Addendum No. 2
Wound Care Relocation
Kings Daughter's Medical Center
Russell, Kentucky

Addendum Issue Date: November 12, 2025

This Addendum is a modification of the Project Manual and Drawings dated September 9, 2025 for the construction of the above listed project. The modifications, revisions, and clarifications are as follows:

Issued by: Zachwieja Workman Architects/Consultants, Inc.

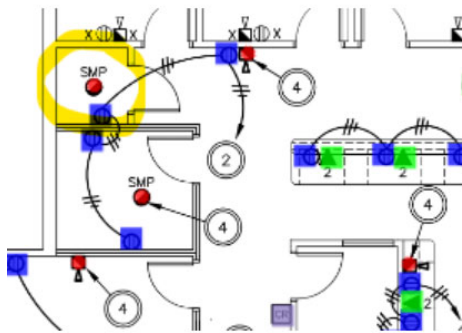
- A. Note: All existing casework in the exam rooms is to be replaced as part of the base bid. See attached sketch A3.2R1 for sink work area in Room LL127.
- B. Revise casework note 2 to read: Bullnose solid surface or Postform edge. See Finish Schedule.
- C. Omit Casework Note 24 and references to it on casework elevations.

A1.0R1

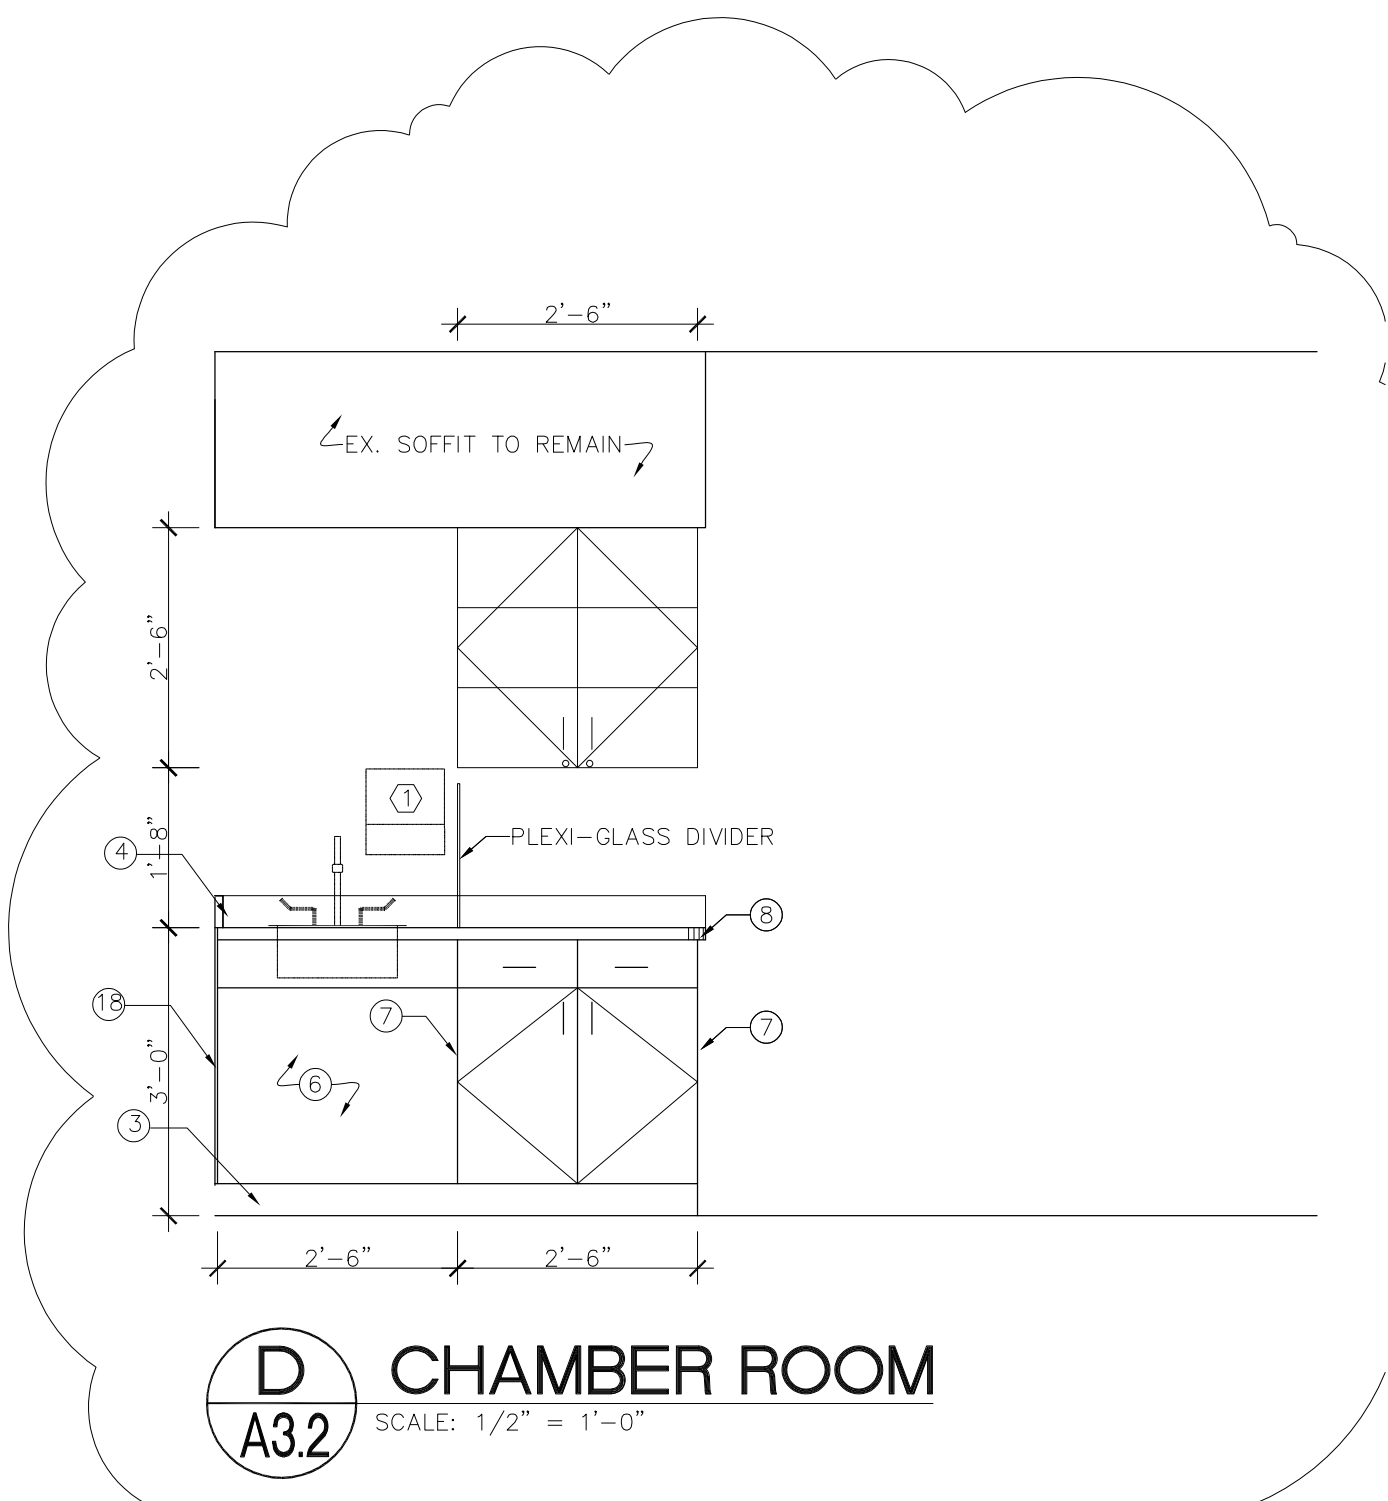
- A. See attached for revisions to the door schedule. Note door 127A has changed from existing double door to new 90min single 4'-0" leaf. Infill area at existing opening.
- B. Clarification: wall around Hyperbaric Chamber shall be no less than 2hr in construction. At this time, the condition of the existing wall is unknown. See Specification Section 012100 for additional information regarding this wall.

DRAWING
E1.2

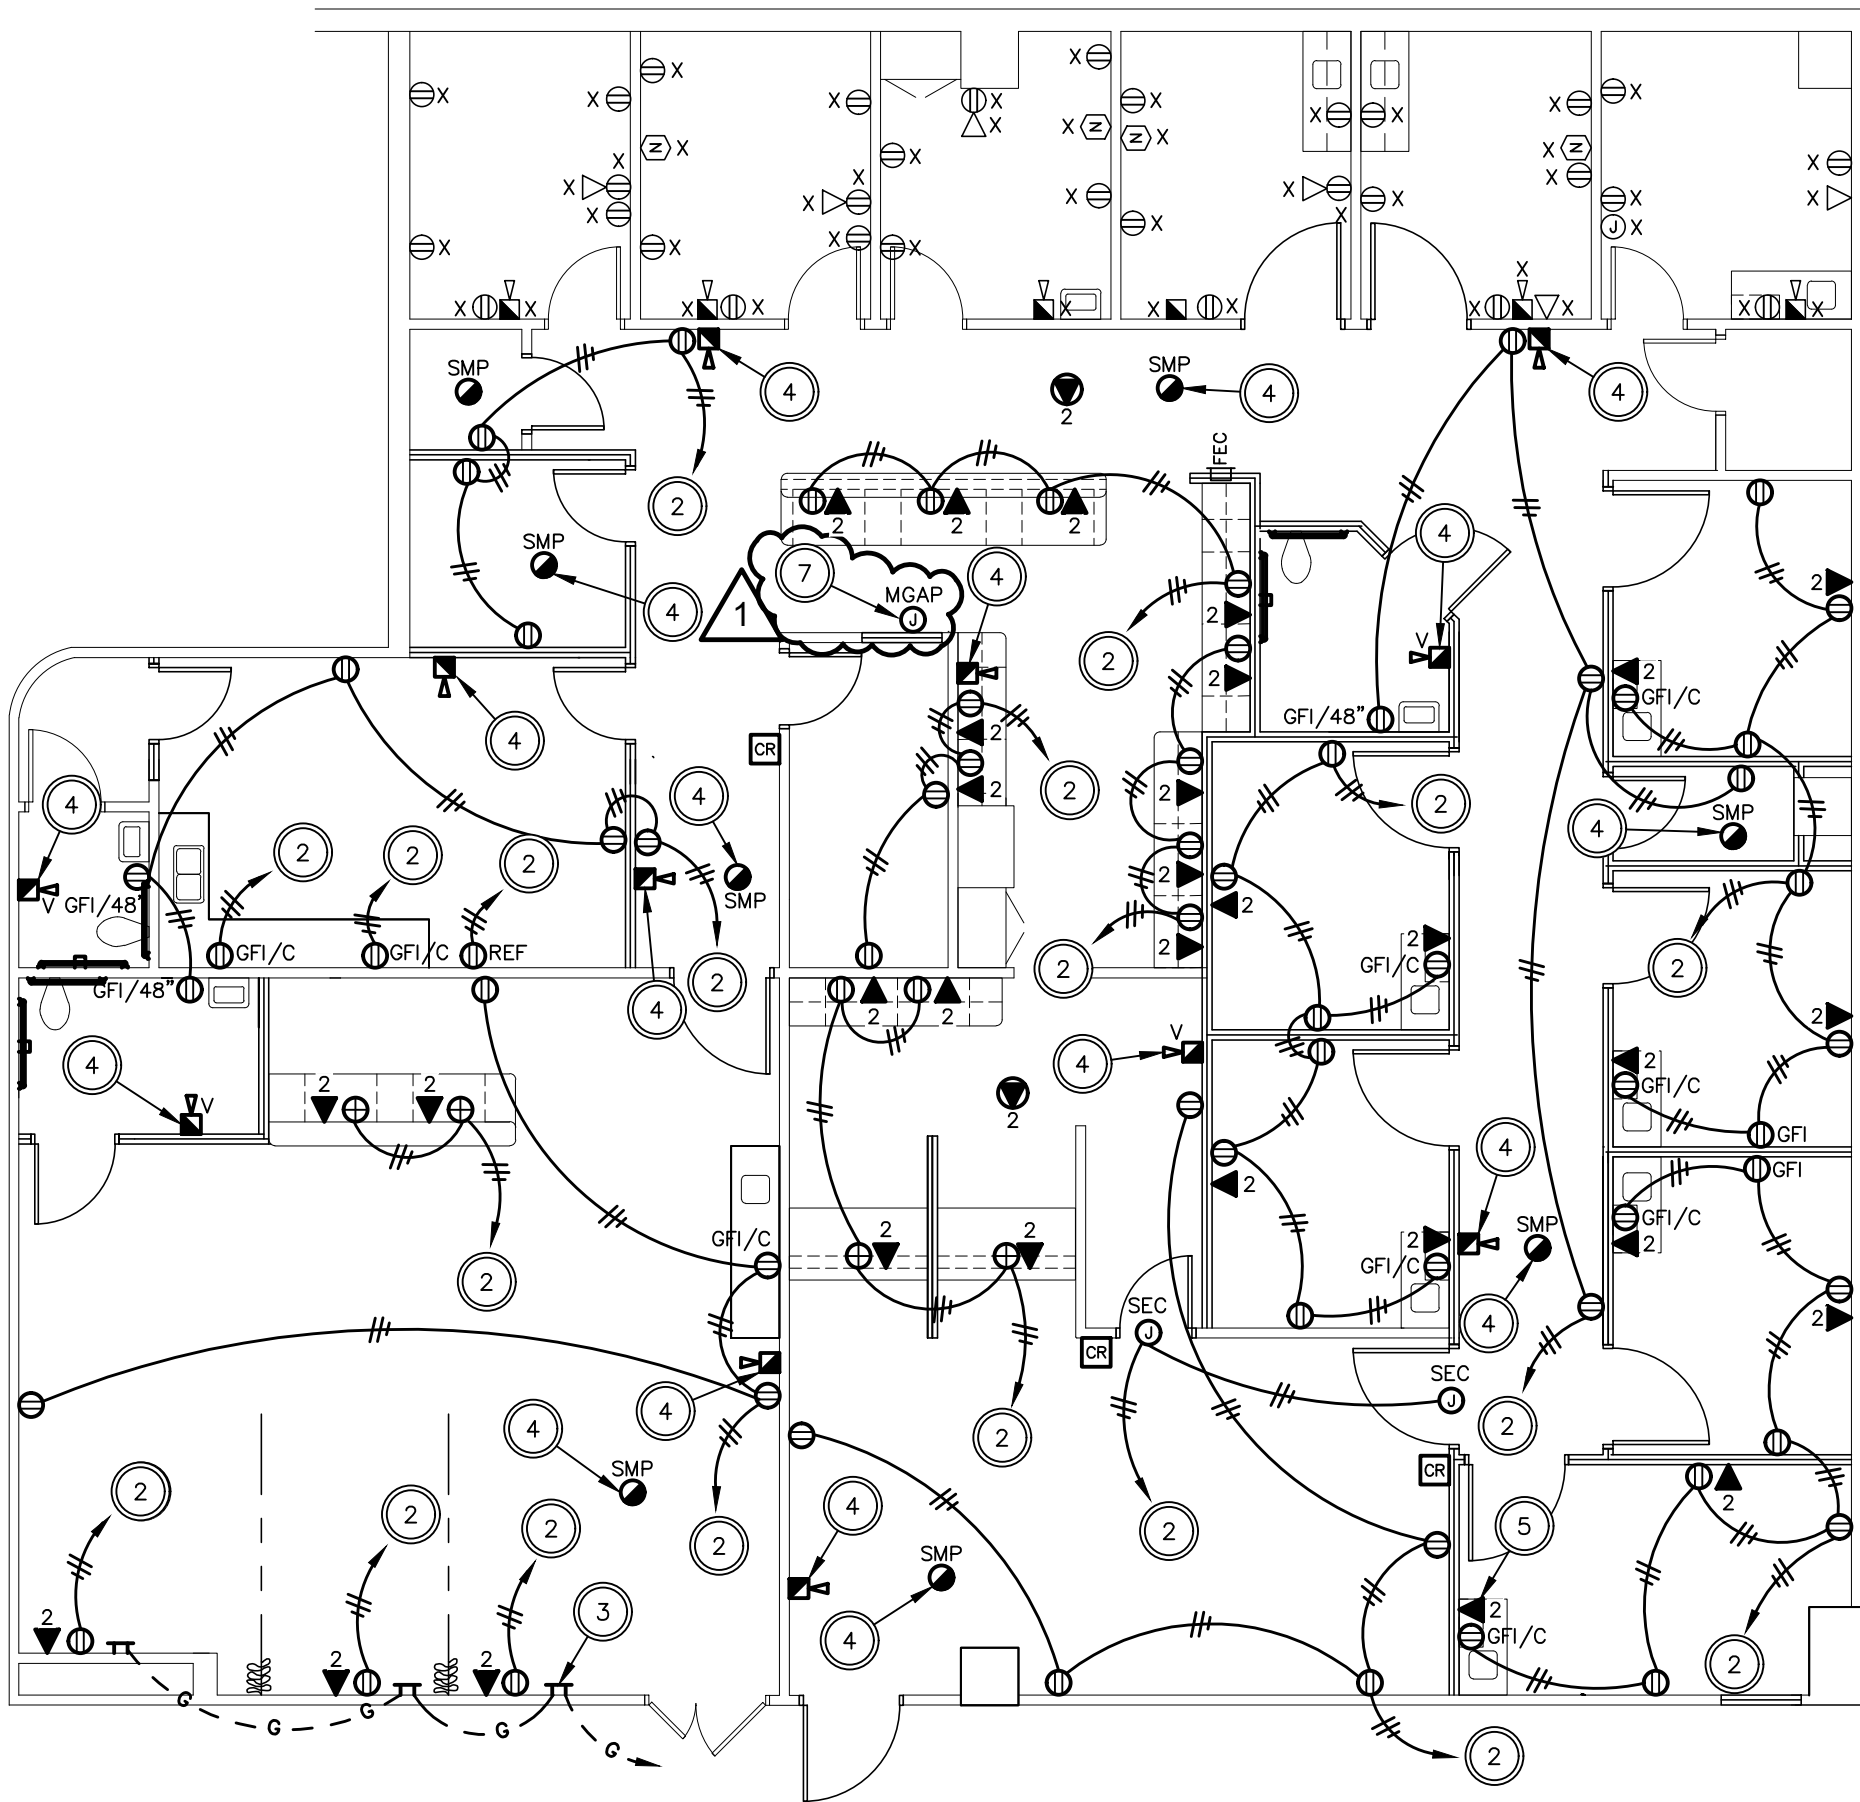
C. Sheet E1.2 shows to disconnect and reinstall the fire alarm devices in the new construction. All of them show to be reinstalled except for (1) smoke detector. Is that a new smoke or should it have the same "Note 4" as all the other relocated devices? If it is an addition, it will change the fire alarm scope of work. Moving them around won't be an issue, but if we add to the existing system, we will have to have the system recommissioned and it will require more work and money. **The smoke detector is to be relocated. All horn/strobe and smoke detectors shall be relocated from existing conditions.**

3. Sheet E1.2 shows to disconnect and reinstall the fire alarm devices in the new construction. All of them show to be reinstalled except for (1) smoke detector. Is that a new smoke or should it have the same "Note 4" as all the other relocated devices? If it is an addition, it will change the fire alarm scope of work. Moving them around won't be an issue, but if we add to the existing system, we will have to have the system recommissioned and it will require more work and money. *See Addendum.*
